RBG-48271

Subject: Supplement to License Amendment Request to Adopt Risk Informed Completion Times TSTF-505, Revision 2, "Provide Risk-Informed Extended Completion Times – RITSTF Initiative 4b" and Application to Adopt 10 CFR 50.69, "Risk-Informed Categorization and Treatment of Structures, Systems and Components for Nuclear Power Reactors"

River Bend Station, Unit 1
NRC Docket No. 50-458
Renewed Facility Operating License No. NPF-47

**Responses to NRC Audit Questions
Related to the TSTF-505 LAR**

Figure 1: Simplified RPS Electrical Failure Logic with Gate Probabilities

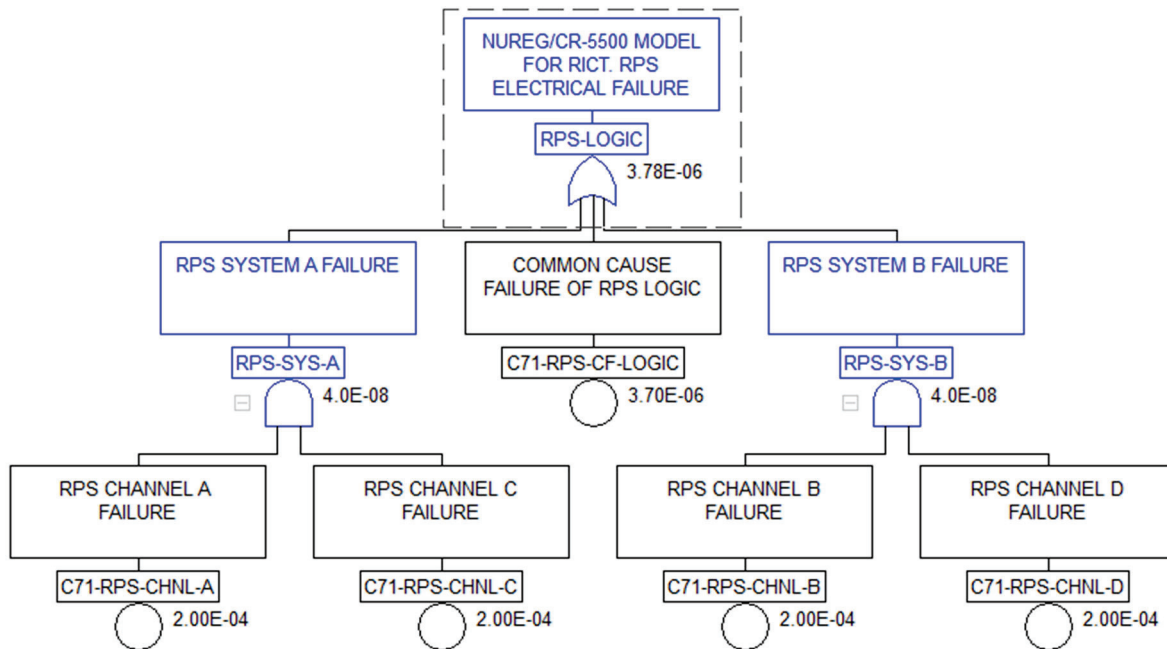
- a) *Regarding TS LCO 3.3.1.A/B, Table E1-1 states that, for reactor protection system (RPS) instrumentation that an RPS failure model is planned to be incorporated into the Electronic Risk Assessment Tool (ERAT) based on NUREG/CR-5500 (Volume 3) "Reliability Study: General Electric Reactor Protection System, 1984-1995," dated May 1999. It also states that the intent of the RBS ERAT RPS model is to be used as a surrogate for unmodeled RPS SSCs. However, it is stated later that the simplified RPS model provides a more conservative result than the NUREG/CR-5500 model when a Function channel is inoperable or bypassed. Clarity is needed to understand how the RBS ERAT RPS channel modeling is more conservative than NUREG/CR-5500 base probability if the base results in exactly matching the NUREG value. The NRC staff notes that in section 5 of NUREG/CR-5500, the overall failure probability appears to include operator manual scram, control rod system, and hydraulic control unit system (scram discharge volume and solenoid operated valves (SOVs)). NUREG/CR-5500 provides the following failure rates: (1) section 3.3 states a failure rate of 3.8E-06 for the channel and trip portion of RPS, and (2) section 5 states the mean RPS unavailability as 5.8E-06. Clarity is needed to understand how the RBS RPS model incorporates all of the necessary SSCs and operator actions to represent the as-built, as-operated plant for the associated proposed RICT LCOs.*

- i. Provide justification that the RBS ERAT RPS model provides conservative results when compared to the NUREG/CR-5500 model. Include in this discussion of the failure probability values used from NUREG/CR-5500.*

- 1) Provide justification that the proposed RBS ERAT RPS model will meet the associated CC-II requirements. Include in this discussion how the use of NUREG/CR-5500 information meets CC-II requirements.*

a) i. The River Bend Station Unit 1 (RBS) RPS model is a simplified five event model with the data of each event derived from the cutset solution of the NUREG/CR-5500 model. Four of the events represent channel or subsystem failures, with one event for each of the subsystems, arranged in a one-of-two taken twice failure logic. The fifth event is a common cause failure leading to system failure. The simplified model excludes the mechanical failures which are not subject to TS 3.3.1.1 and are modeled in detail in the fault tree model. The following Figure 1 illustrates the RBS RPS electrical model logic:

The model is designed to be applied for Risk-Informed Completion Times (RICTs) as a total channel inoperable for any function within that channel being inoperable. When no channels are inoperable, quantification of the simplified RBS model results in the same numerical solution as the NUREG/CR-5500 model for the electrical component failures.

Figure 2: Division 1 Base (All Relays Operable) Model

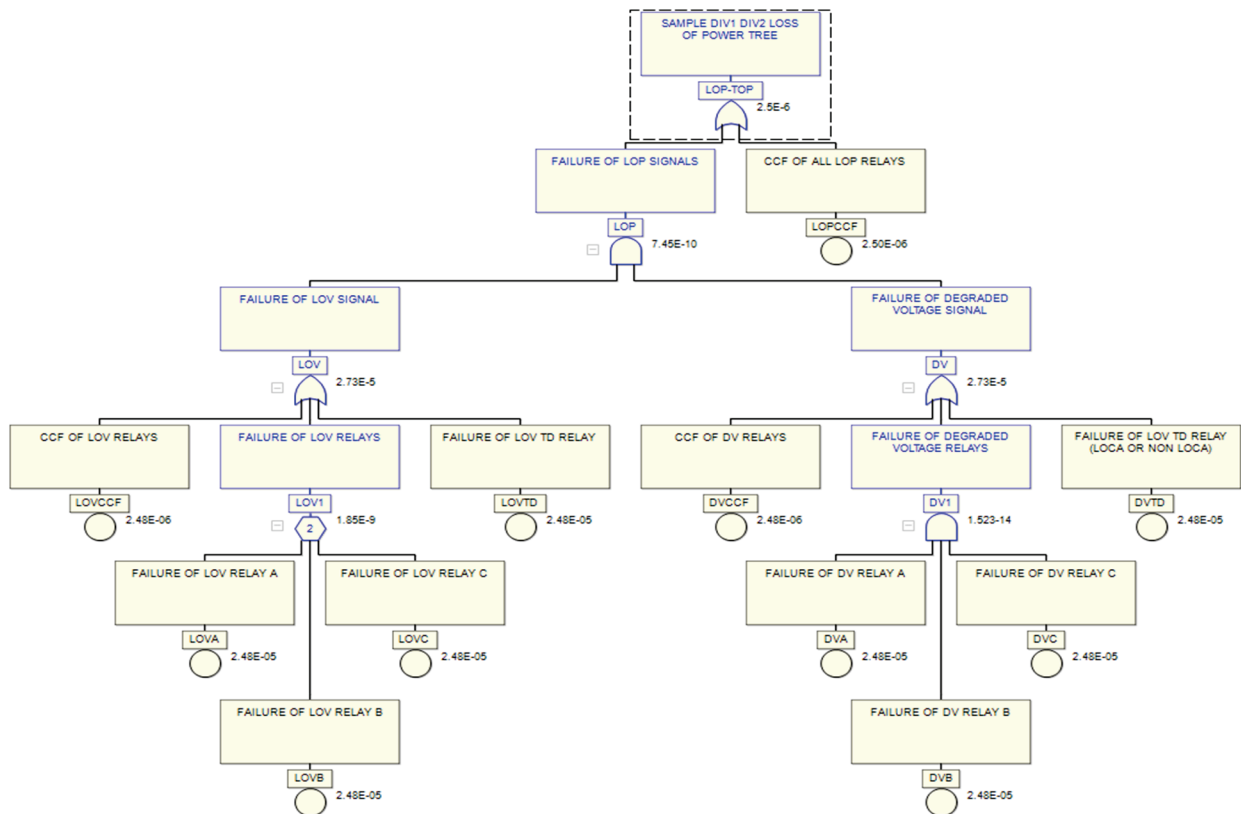
- i. Detail the intended increase in failure probability of the surrogate associated with this LCO.*
 - ii. Provide justification that increasing the surrogate's failure probability is conservative or bounds the LCO function.*

f) ii. The NUREG/CR-6928 data for relay failures is $2.48E-5$. This value is applied to the LOP model as a conservative estimate. A fault tree model was created in response to this question to demonstrate that use of this single point estimate approach is conservative compared to a more detailed model. The model is based on the plant logic, NUREG/CR-6928 2020 data and a conservative Common Cause Failure (CCF) factor of 0.1. Figure 2, Division 1 base (all relays operable) model, is shown below.

Using the base model for Division 1, a top gate probability of 2.5E-6 was calculated as shown in the fault tree above. Note that the PRA models the initiating event, Loss of Offsite Power, for which both the Loss of Voltage (LOV) and Degraded Voltage (DV) function will be challenged.
